ZAYO'S PRINEVILLE TO RENO PROJECT

CPUC MINOR PROJECT REFINEMENT FORM

AL - ALTURAS TO JUMPER RIDGE RD

RFI_0510_MP_L_AL31to32

31 OF 105

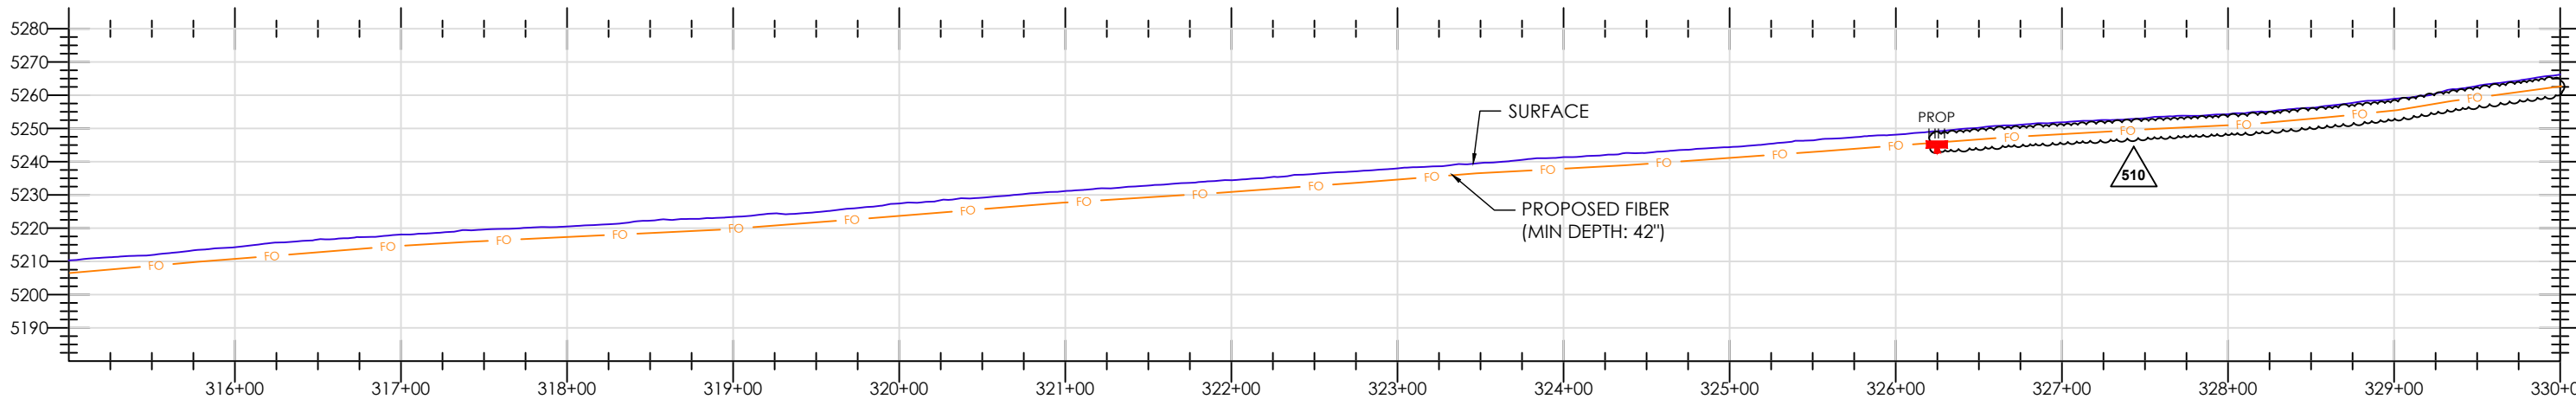
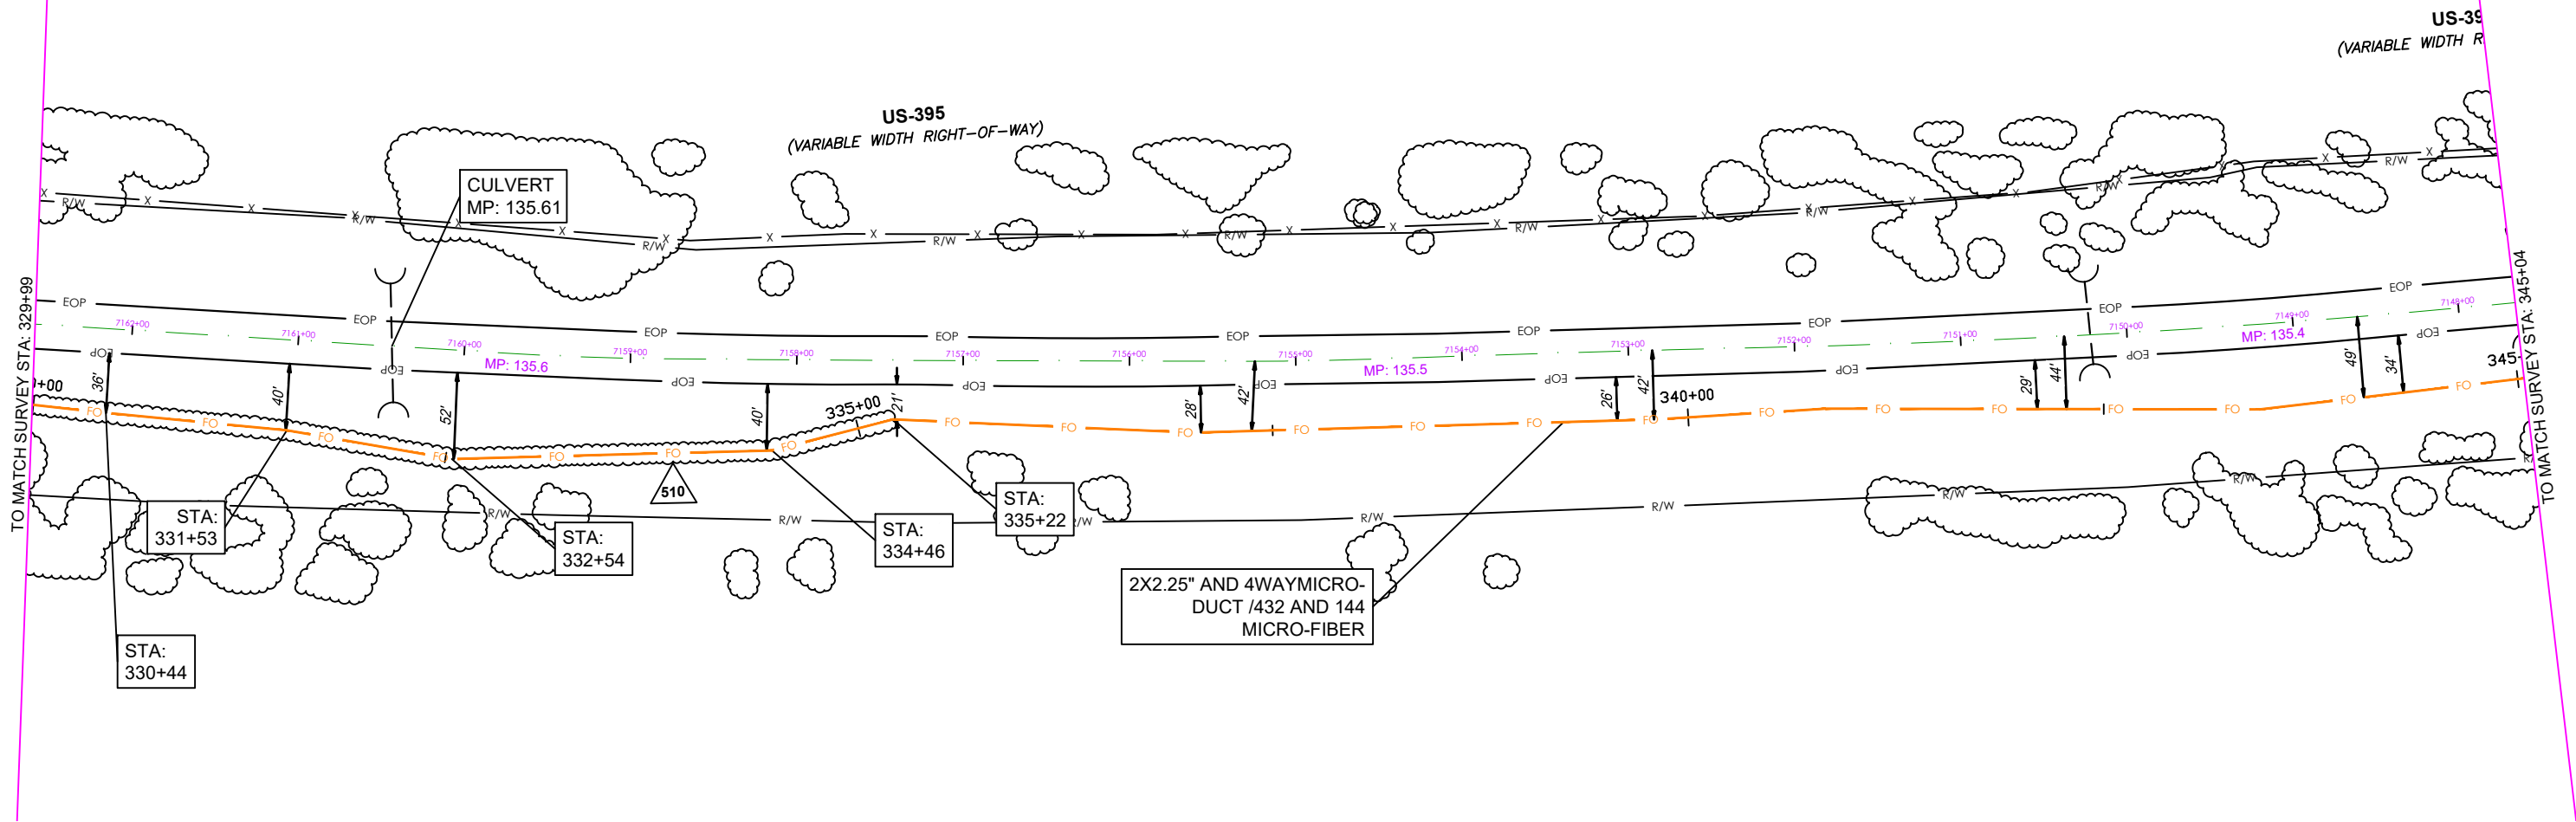
RFI NO. 0510
MOVE RUNNING LINE IN VARYING DISTANCE FROM 28FT TO 52FT FROM EOP TO AVOID ANY RESOURCES IN THE AREA. ELIMINATE THE BORE AT CULVERT MP L-135.61. STA. 335+18 TO 326+24

32 OF 105

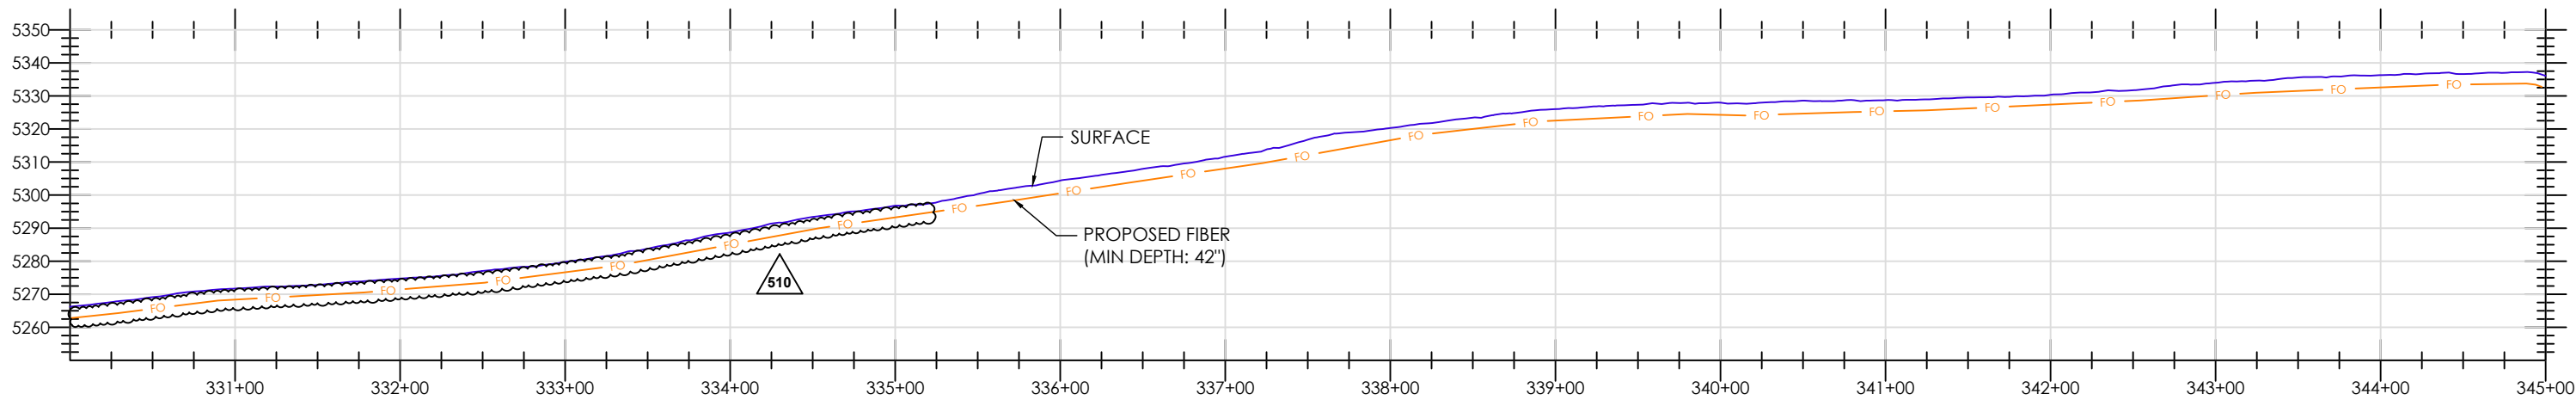
RFI NO. 0510
MOVE RUNNING LINE IN VARYING DISTANCE FROM 28FT TO 52FT FROM EOP TO AVOID ANY RESOURCES IN THE AREA. ELIMINATE THE BORE AT CULVERT MP L-135.61. STA. 335+18 TO 326+24
